NTS 02-E & NTS 03-E Firmware Release Notes

VERSION 3.21r7 (May 2018)

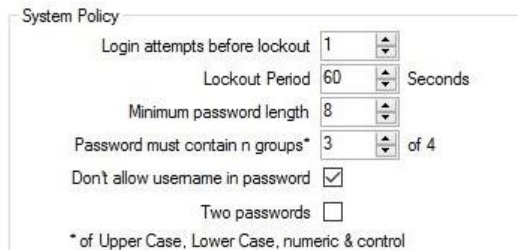
- **Improvement:** While configuring NTP multicast address, if the IPv4 address assigned for multicast is an invalid address, then the clock will use the broadcast MAC address. For valid IPv4 multicast addresses a valid multicast MAC will still be used.
- **Improvement:** Clocks getting their Sync from IRIG-B or PTP will advertise Stratum-1. Previously they were advertised as Stratum-2
- **Improvement:** Added ability to lockout a user for a period following several unsuccessful login attempts. Both the number of unsuccessful attempts and the period of lockout can be configured.

By default, this feature is disabled (Logging attempts before lockout set to 0) and this will be the case for clocks upgraded to this version.

To prevent the leaking of security information there is no notification to a user that the lockout is in place, and the standard login failed message will be displayed.

The lockout is based on the user account and operates regardless of the IP address that the attempt is made from or if the attempt is made via SNMP or the Config Tool. Similarly, a failed login via any method or from any address adds to the users failed login attempts count.

The lockout is per account and a lockout on one account does not prevent other accounts from logging in.

Subsequent incorrect login attempts during the lockout period will not increase that period. SNMPv3 traps authenticated with the credentials of a locked-out user will still be sent.

Config Tool 4.3.1.0 Is required to access this feature.

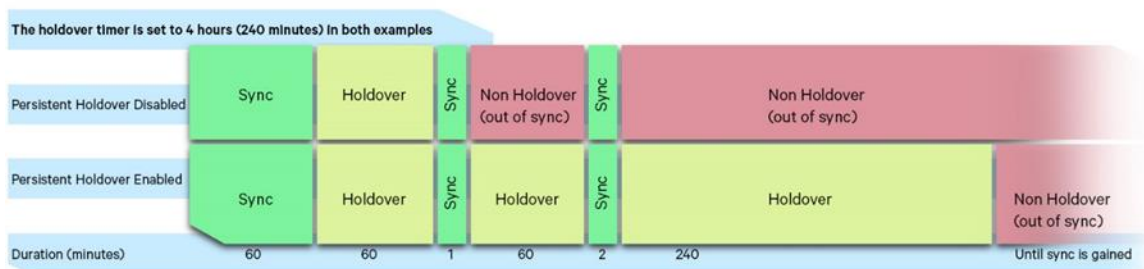
- **Feature:** Added support for enabling the persistent holdover availability option. Tekron Configuration Tool 4.2.1.10 or later is required to enable this option. Normally, the clock can only enter holdover if it has been in sync for at least 5 minutes. If persistent holdover is enabled, and the clock has initially been in sync for at least 5 minutes, then the clock can still enter holdover if it experiences a sync switching condition. For example, sync is lost, regained for less than 5 minutes, then lost again. Such a condition may exist when GNSS jamming is present, or in the case of a poor antenna installation.

Please note, when entering holdover after a period of intermittent sync the holdover period timer is reset. This may cause the clock to enter into an extended holdover period, if the sync switching condition continues to be present. By disabling persistent holdover, you can ensure that the time in holdover is not extended by periods of intermittent sync lasting less than 5 minutes.
